SERVICE BULLETIN

Subject: New Decals Location in Engine Room Bulletin Type: Field Fix Conditional

Bulletin No: TS45-FC-2401

Vehicle Model: TS 45

Figure-2

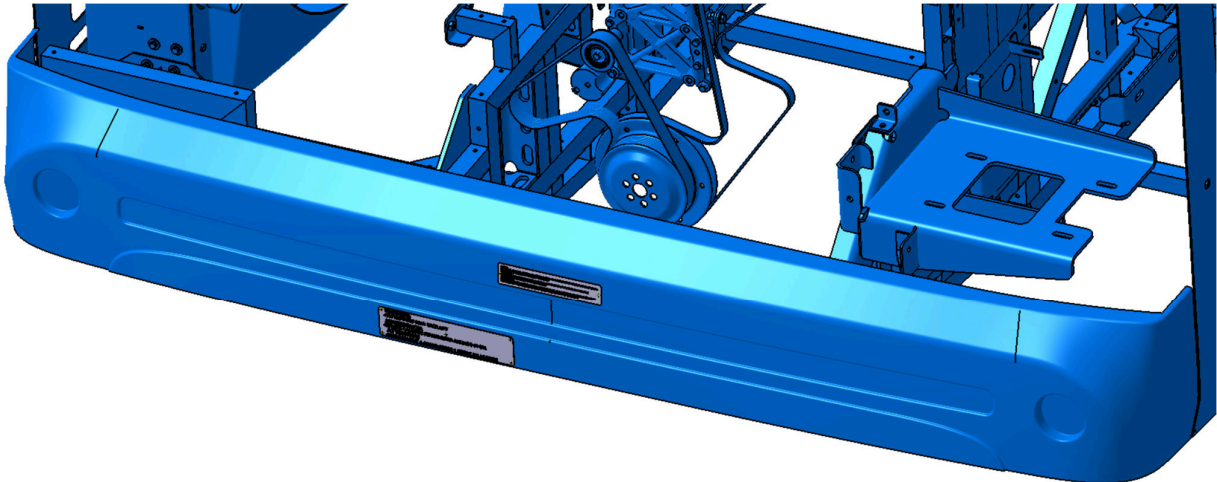
2- Mount the label numbered 9050-314Y on the rear bumper with TC395107Y. (See Figure-2).

Figure-3

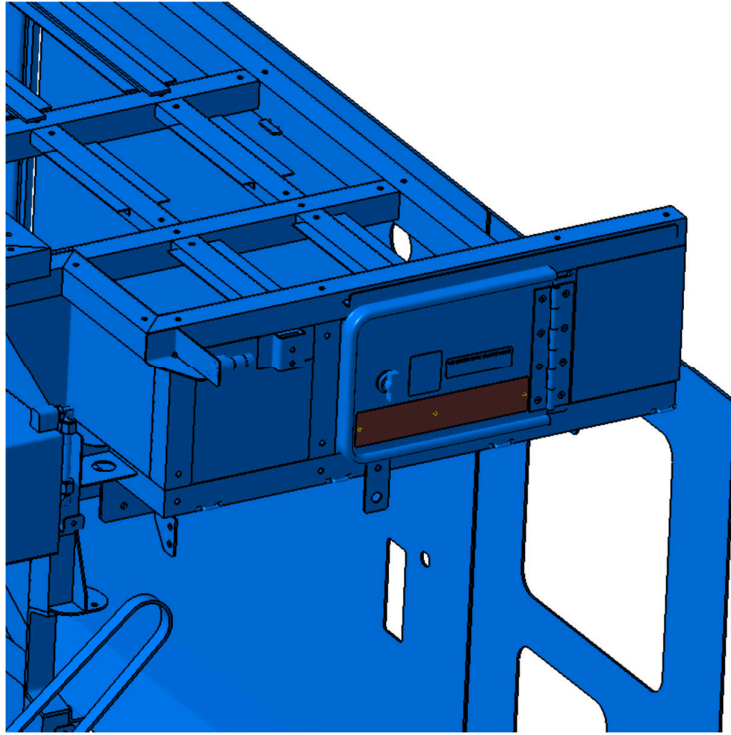
3- Mount the label numbered 9050-315Y on the toilet filler cap with TC395107Y. (See Figure-3).

Figure-4

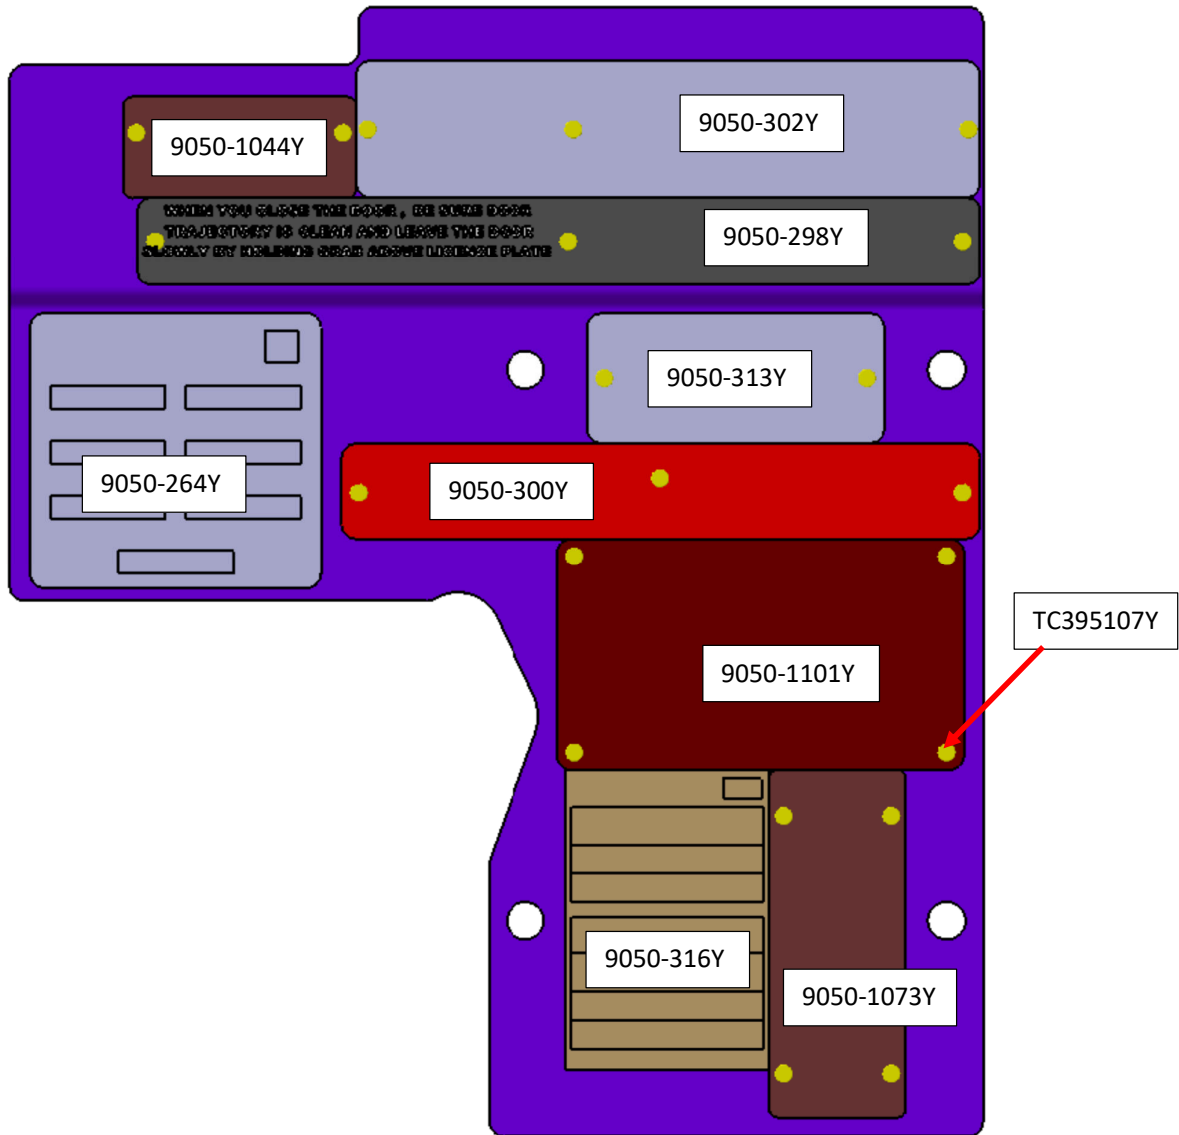
4- Mount labels shown in the picture below on the panel numbered 9325-7425Y with TC395107Y.
(See Figure-4).

Figure-5

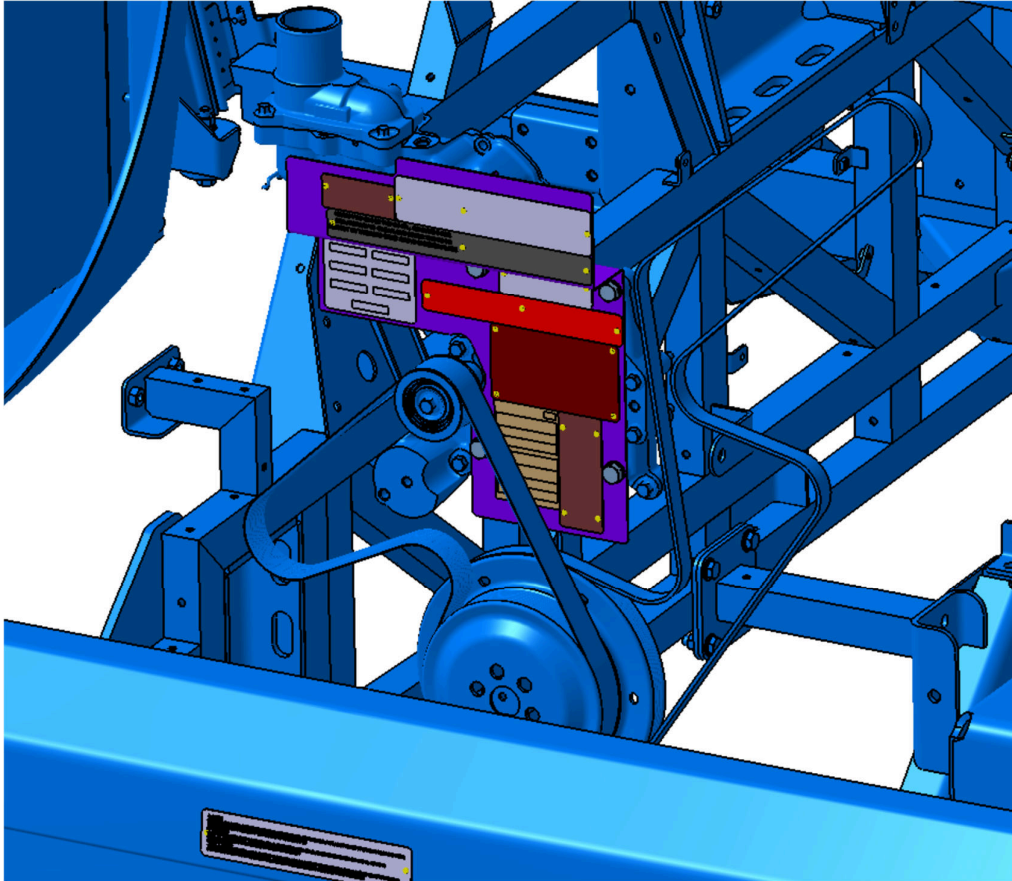
5- Mount the label panel numbered 9325-7425Y on the engine. (MF133060Y, MF450407Y 4pc)
(See Figure-5).
